Historic Preservation Board File No. 25-0676

2201 Collins Avenue

Presentation by Law Offices of Kent Harrison Robbins, P.A.
on behalf of the Roney Palace Condominium Association, Inc.

March 17, 2026

① DECK SECTION - PROPOSED
SCALE: $\frac{1}{8}" = 1'-0"$

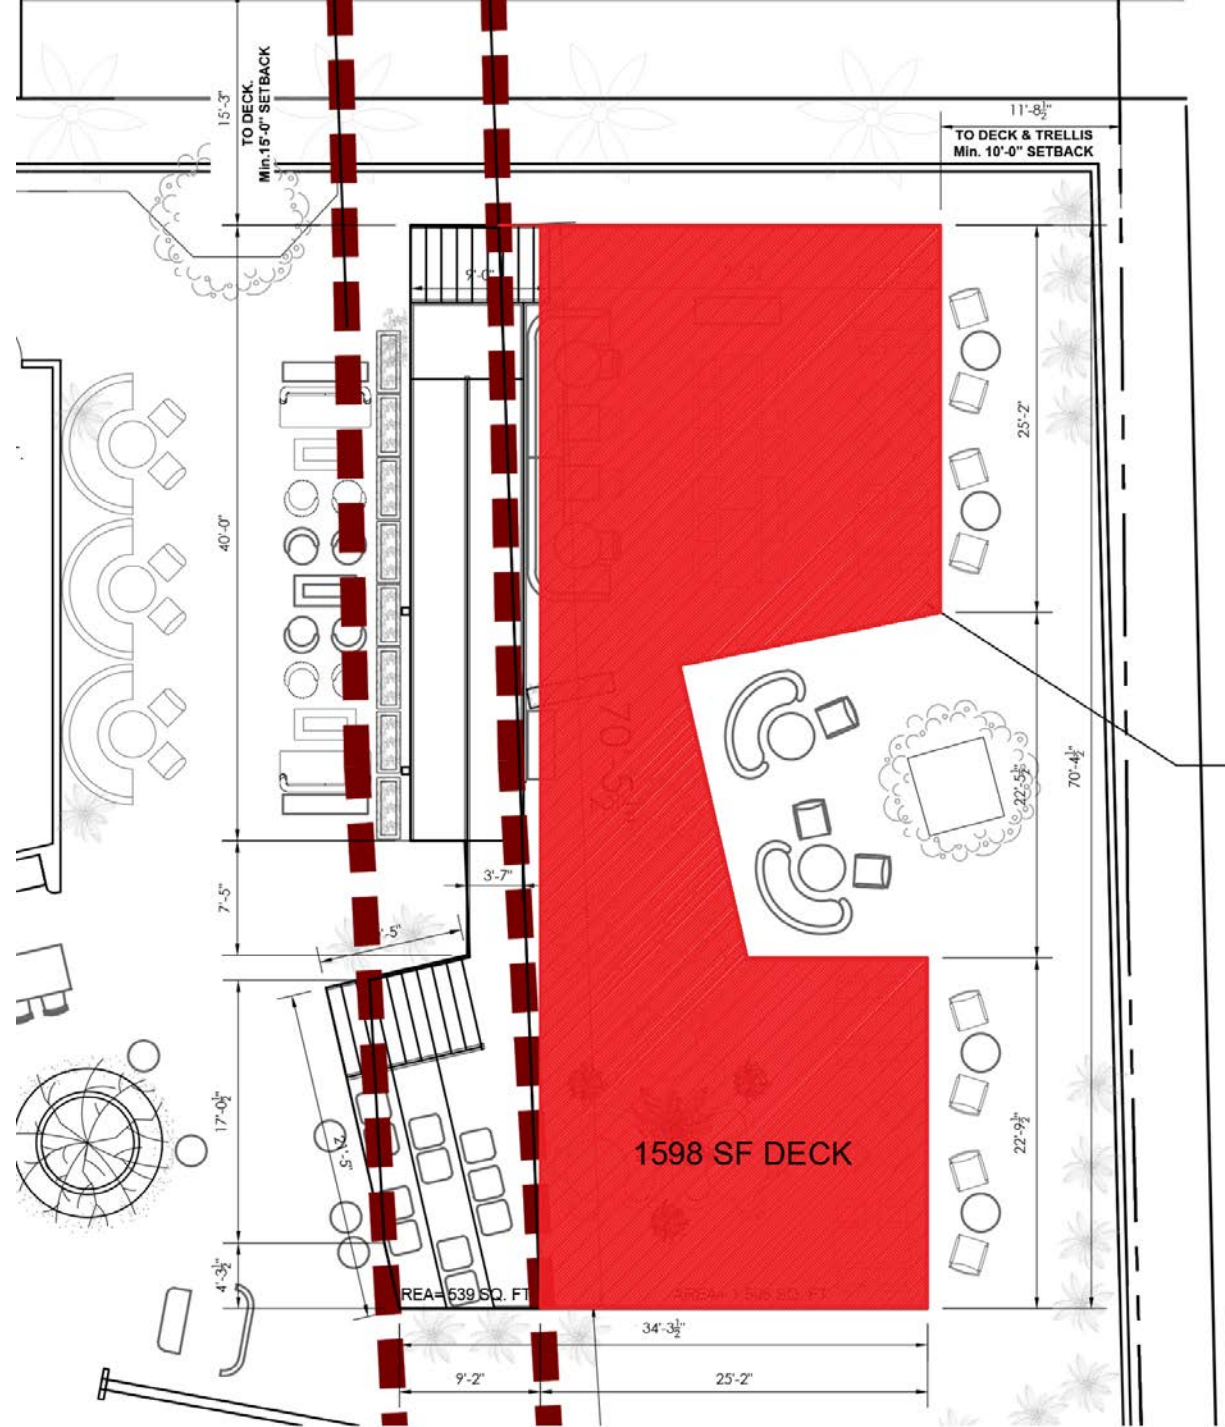
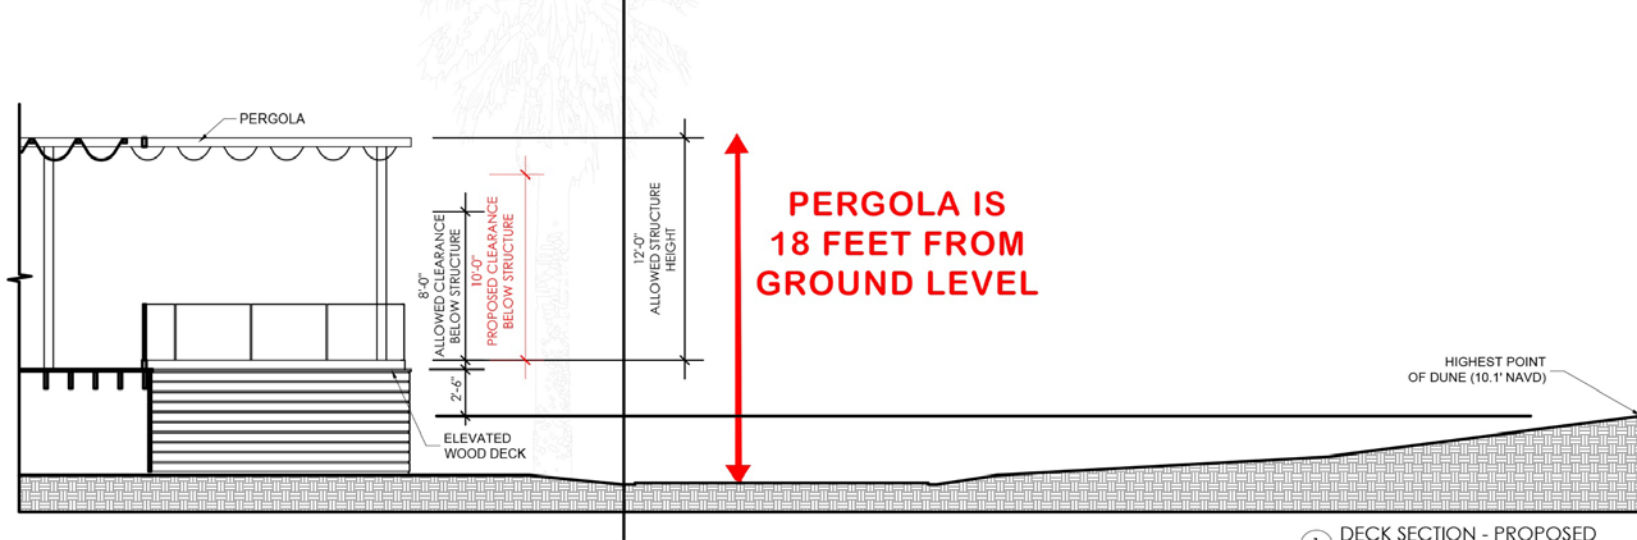
The applicant is requesting variances associated with the redevelopment of the rear yard oceanfront area. The proposed improvements include the demolition of the existing pool bar, wood decking, and four cabanas in order to construct a new 1,598 square foot deck and pool bar that will serve as an outdoor amenity area for the proposed beach club. The subject site contains approximately 10,985 square feet of oceanfront area located within the Dune Overlay. Staff notes that the existing W Hotel is a non-contributing structure constructed in 2010. The dune and oceanfront overlay regulations applicable to this property were in effect prior to the construction of the building. As such, the site was subject to these standards at the time of its development, and it is difficult to establish that a true hardship or practical difficulty arises from the application of regulations that have remained substantially unchanged since the building was constructed. The Board should consider this context in evaluating the variance requests.

increasing the impervious area by approximately 60 square feet compared to existing conditions.

Staff has concerns regarding the concentration of dining area and associated canopy structures proposed within the dune environment. The large retractable canopy structures, combined with the consolidated deck area, represent a significant intensification of covered and enclosed space within an area where the overlay regulations are specifically intended to limit such development.

From Page 11 of the Staff Report

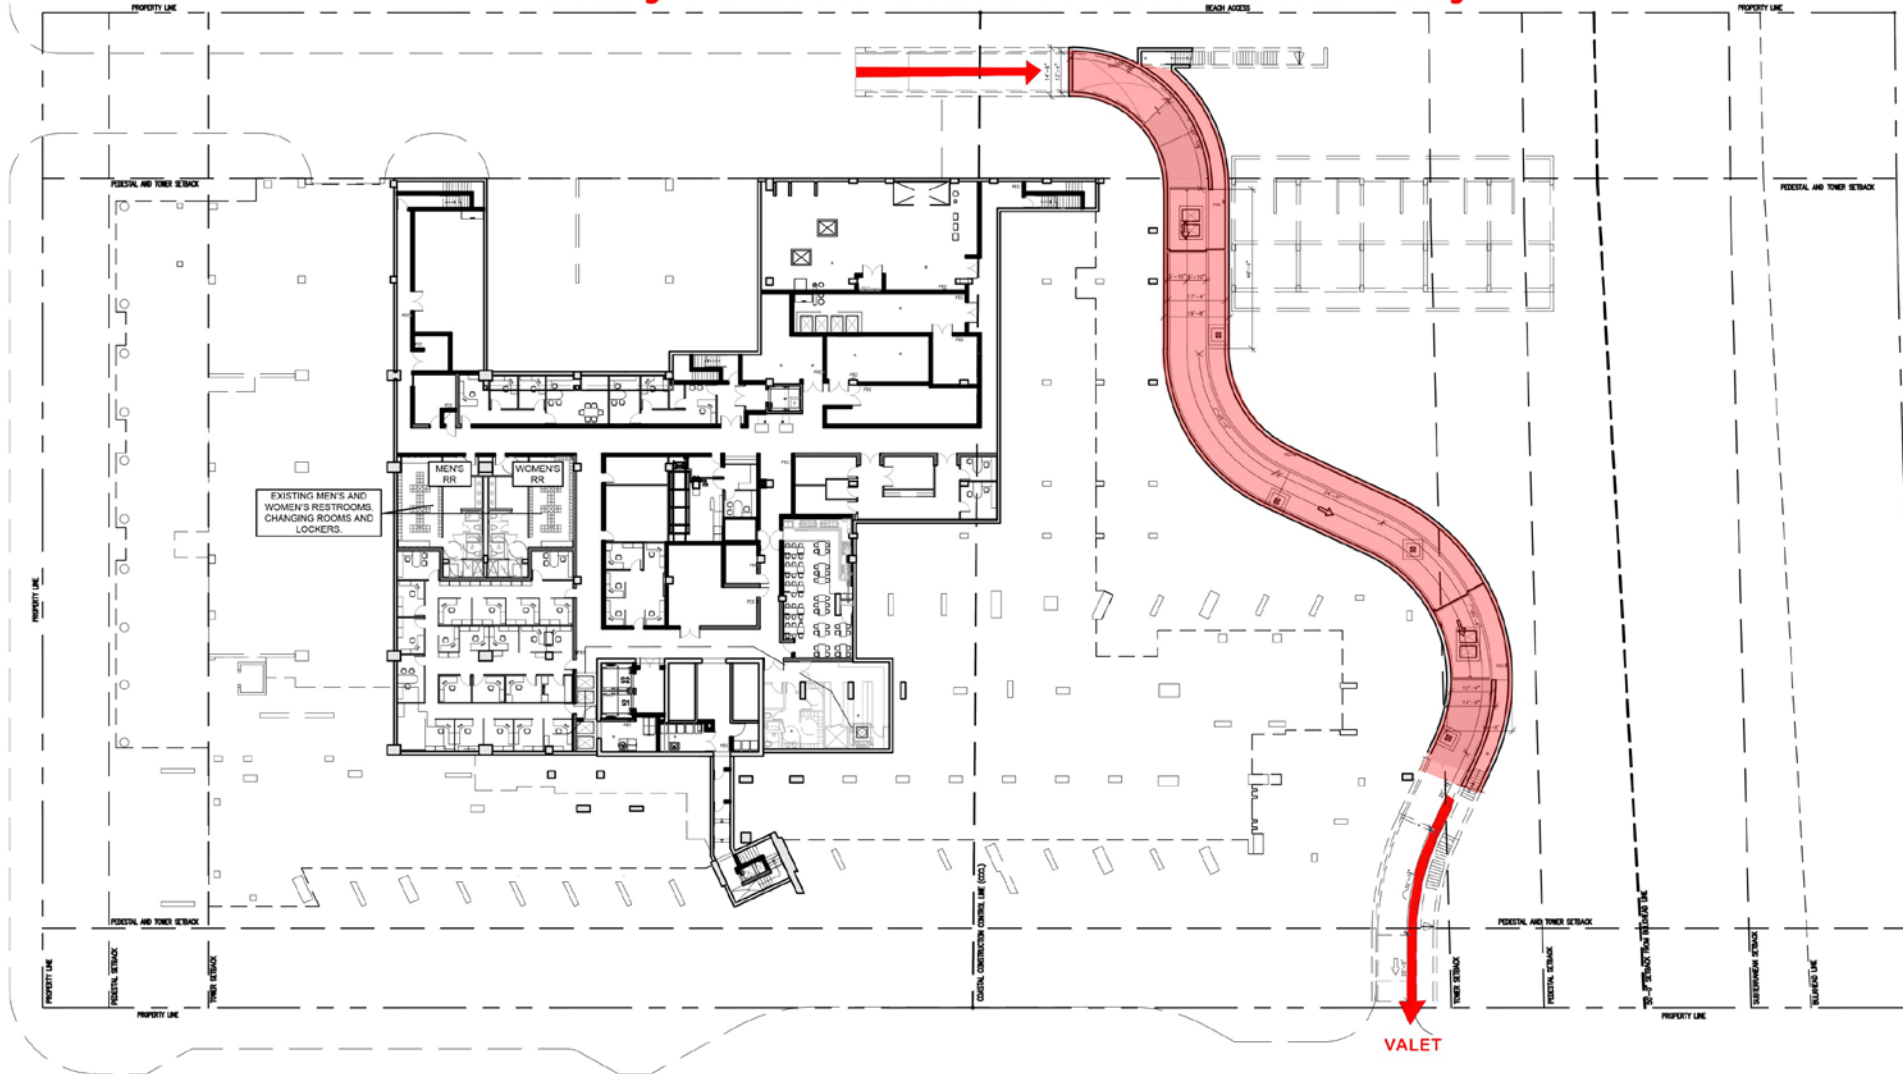
Variance #2 pertains to the maximum permitted height clearance for a shade structure within the Dune Preservation Overlay. The applicant is proposing a trellis system that incorporates a retractable fabric awning, side fabric shades, and a clear glass roof element. The code limits shade structures within the dune area to a maximum height clearance of eight feet. The proposed trellis system has a height clearance of ten feet, exceeding the maximum by two feet. The applicant has not demonstrated that the additional height is the minimum necessary to meet a practical difficulty specific to this property, given that the beachfront location and applicable regulations were established conditions at the time the building was constructed. If the Board determines that the variance is appropriate, staff recommends as a condition that no more than 50 percent of the covered structures exceed the maximum permitted eight-foot height clearance.

PROPOSED CONDITIONAL USE PERMIT
SCALE: 1" = 40'-0"

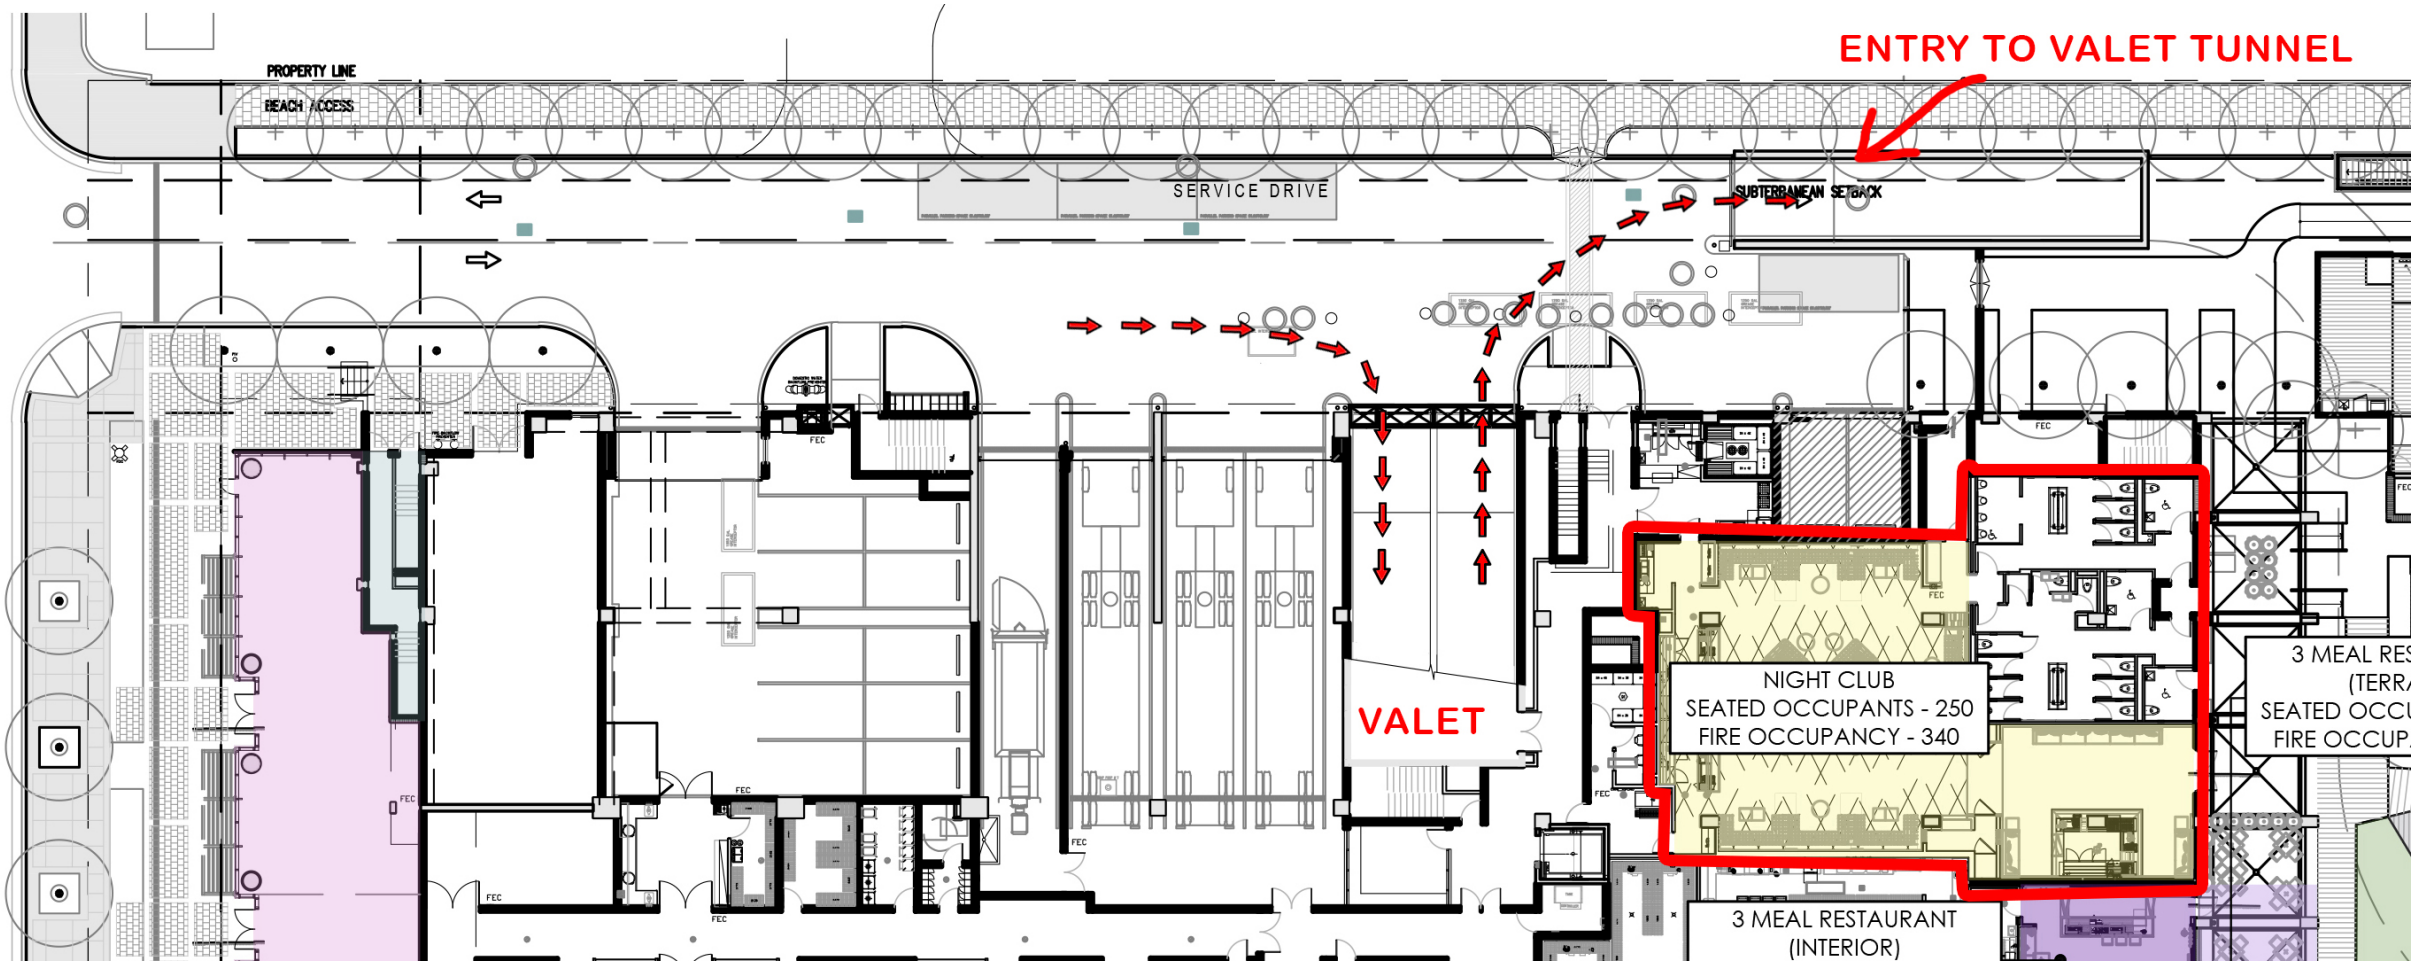
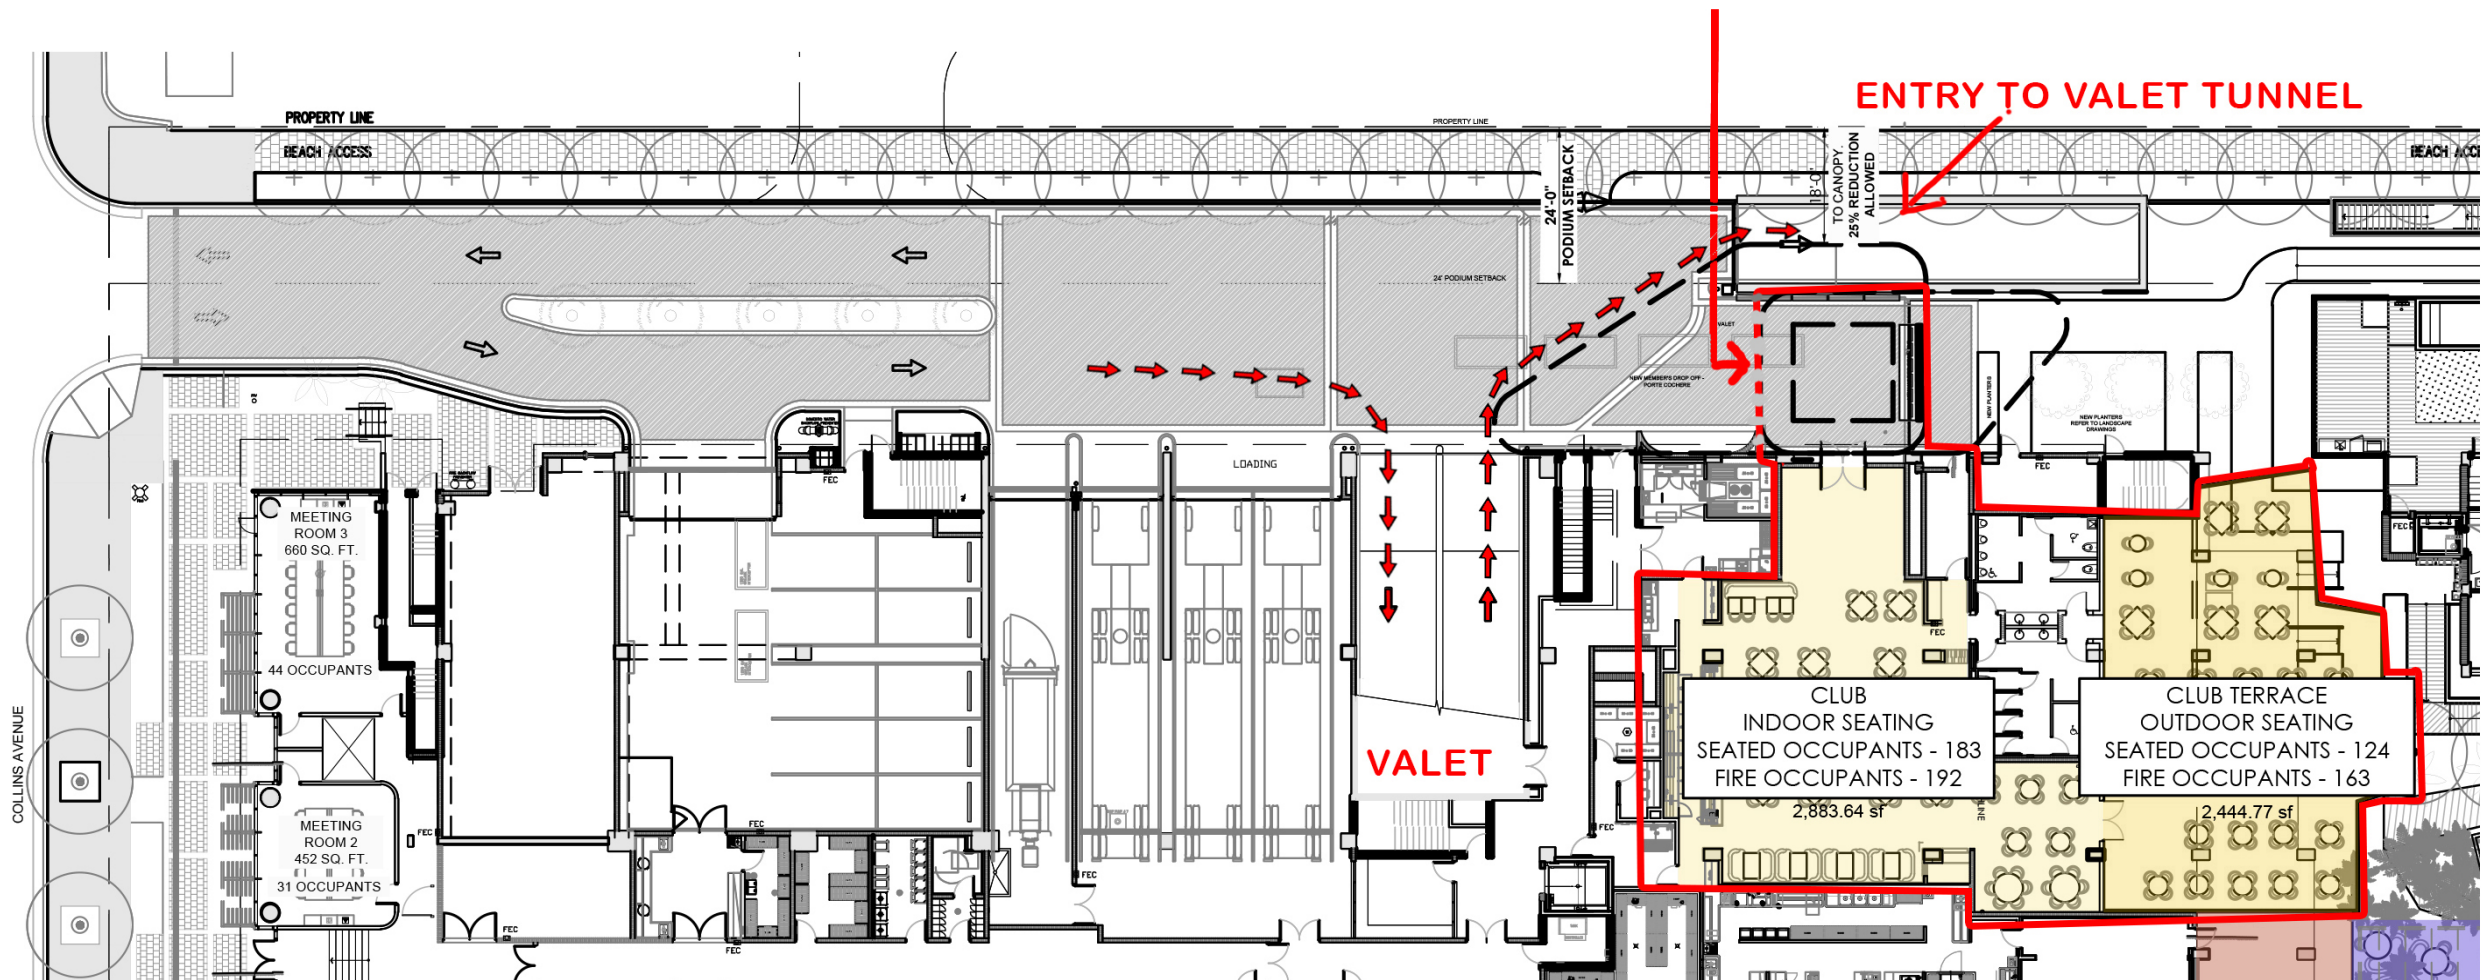
Venue	Interior Seating	Exterior Seating	Open	Total Seating	Fire Capacity
3 Meal Restaurant	144	276		420	506
Bar/Lounge	80	98		178	181
Tenant Restaurant	189	137		326	545
Patisserie	85	88		173	267
Club	183	124		307	355
Beach Club		237		237	418
Pool		376		376	658
Total/Type	681	960	0	2017	2931
					Grand Total
				1435

Conditional use permit originally approved and provided.
